M E M O R A N D U M

June 1, 2016

SUBJECT: Public hearing and consideration of a Landmark Alteration Certificate application to add new round windows to the street facing gables of the contributing houses at 521 Maxwell Ave. in the Mapleton Historic District, per Section 9-11-18 of the Boulder Revised Code 1981 (HIS2016-00121).

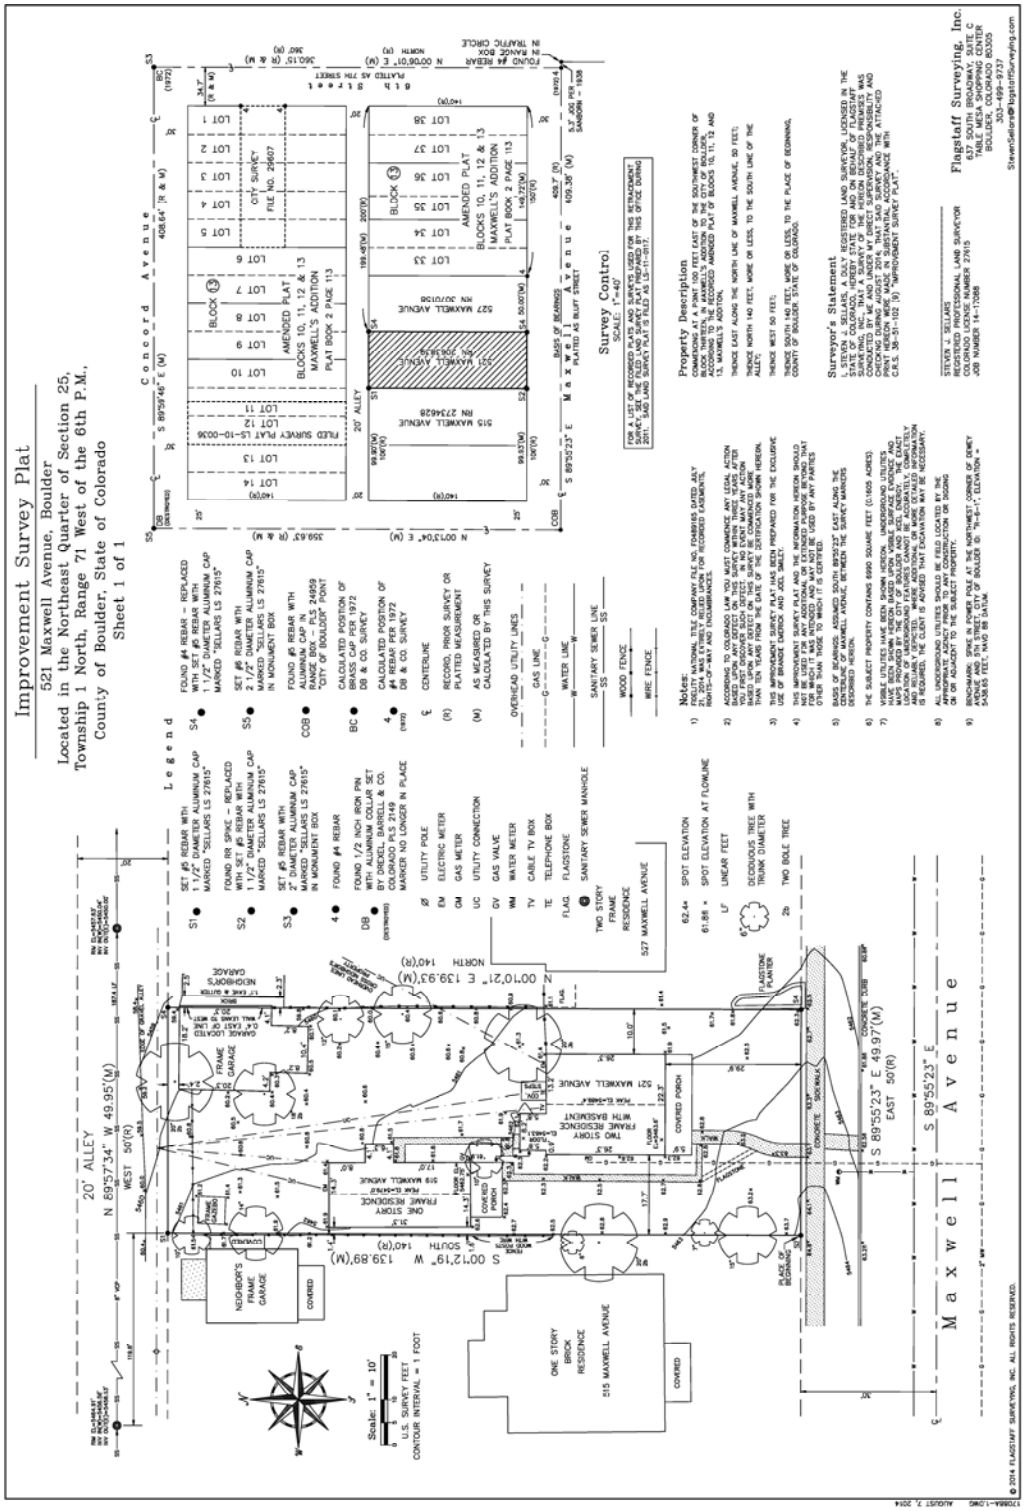
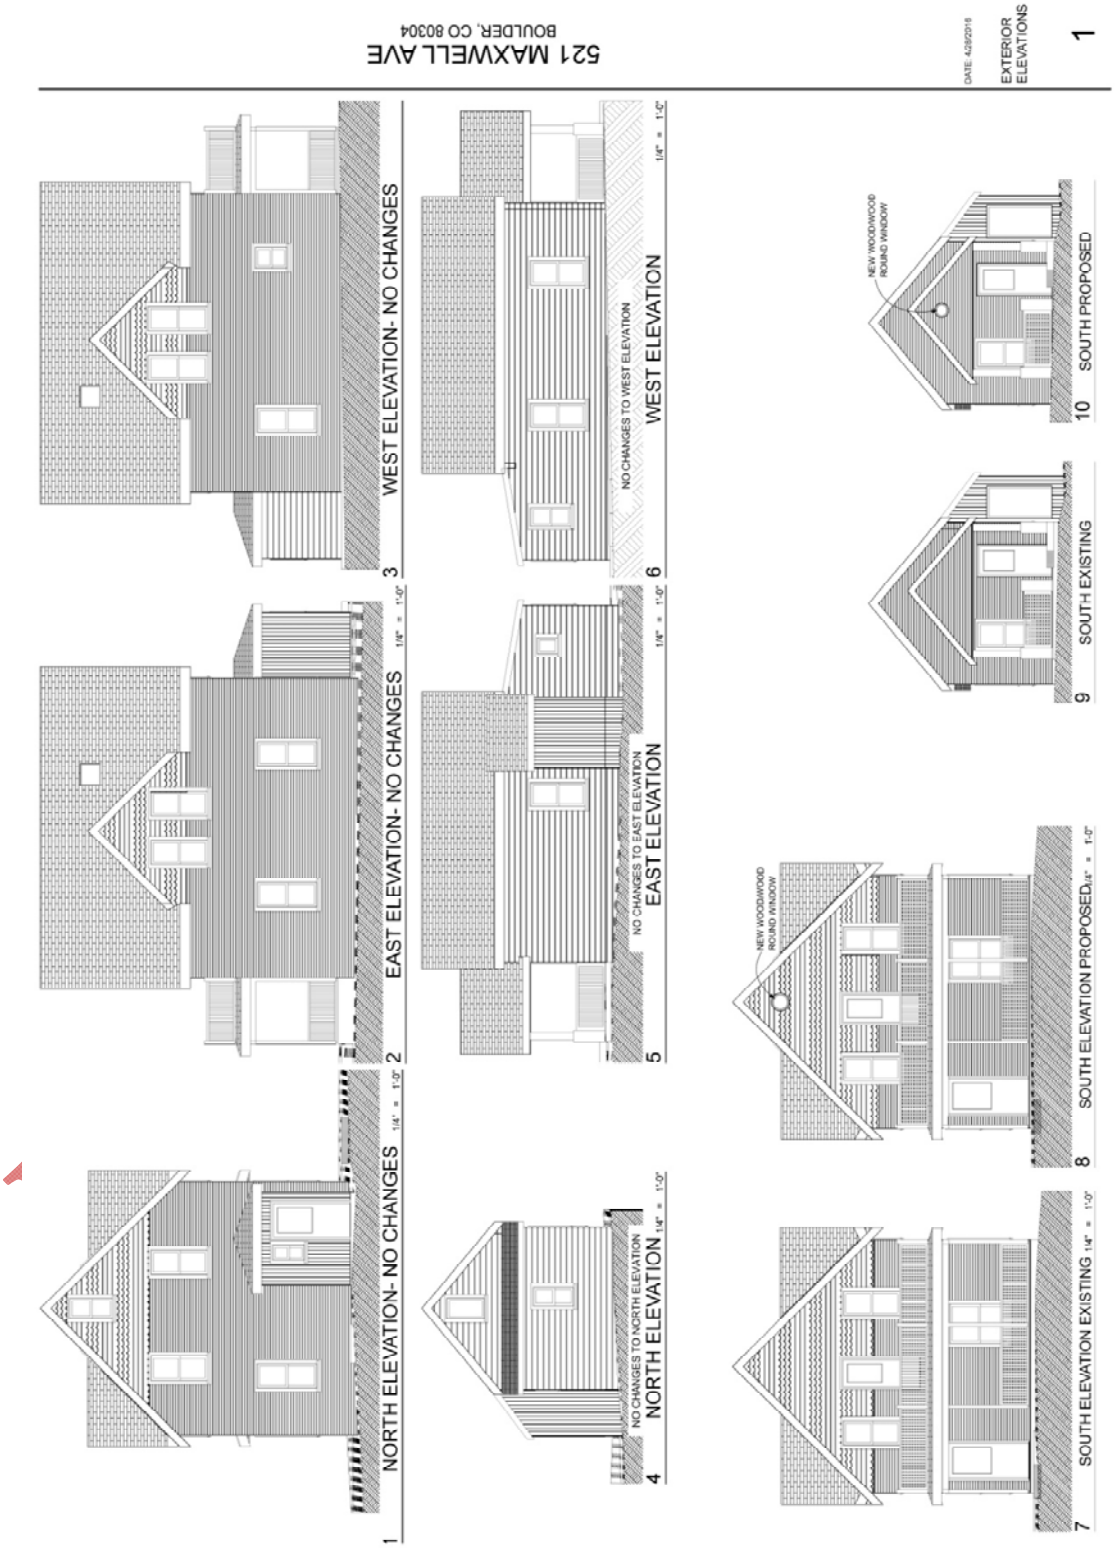
The houses were constructed in c.1902 and 1906, within the period of significance for the Mapleton Hill Historic District and retain their original form, massing, scale, and materiality and should be considered contributing to the Mapleton Hill Historic District. Staff considers that the south faces of both houses are "primary elevations" as defined in the *General Design Guidelines* and that adding new round windows would alter the historic character of the façades of the contributing houses, thereby damaging their historic character.

Staff finds that the proposed new round windows on the primary elevations of the contributing buildings at 521 Maxwell Avenue to be inconsistent with Section 3.7(1), (2) and (6) of the *General Design Guidelines*, Section I of the *Mapleton Hill Historic District Design Guidelines, The Secretary of the Interior's Standards for the Treatment of Historic Properties (Rehabilitation)* and incompatible with the historic character of the property within the Mapleton Historic District.

3.7	**Windows, Storm Windows, and Shutters**		
	Windows, the elements that surround them, and their relationship to one another are one of the most important character-defining elements of a historic building and should be preserved… Windows on elevations visible from public ways, particularly the façade, are especially important…		
	GUIDELINES:	ANALYSIS:	CONFORMS
.1	*Retain and preserve existing historic windows, including their functional and decorative features, such as frames, glass, sashes, muntins, sills, heads, moldings, surrounds, and hardware. Because windows near the façade are particularly critical to the character of historic buildings, their protection may supercede the protection of historic windows elsewhere.*	The proposed windows are to be located on a primary elevation of contributing buildings. Adding new openings that will change the street-facing character of historic buildings is inappropriate. Redesign to eliminate the round windows and explore alternative ways to provide light to the interiors of these houses.	NO

.2	*Preserve original window locations; do not move windows from their historic placement.*	There is no documentary evidence to suggest that round windows were ever located on the façade of either house at 521 Maxwell Avenue and so proposal cannot be justified in that it will alter the historic character of the most important and visible faces of these historic houses. Redesign to eliminate the round windows and explore alternative ways to provide light to the interiors of these houses.	NO
.6	*The location of the window(s) proposed for retrofit or replacement is important in assessing their significance to a historic building. In general, the more important the elevation where the window is located, the less likely that retrofit or replacement will be appropriate. Elevations will be categorized as*	The proposed new windows are located in a very prominent location in the primary elevation. Addition of new windows to on the primary elevation only if historic documentation exists and new fenestration is a recreation of a historic condition.	NO

- Staff recommends that the applicant revise the proposal to eliminate the new round windows on the primary elevations of these two contributing buildings and explore other alternatives to provide additional interior light.
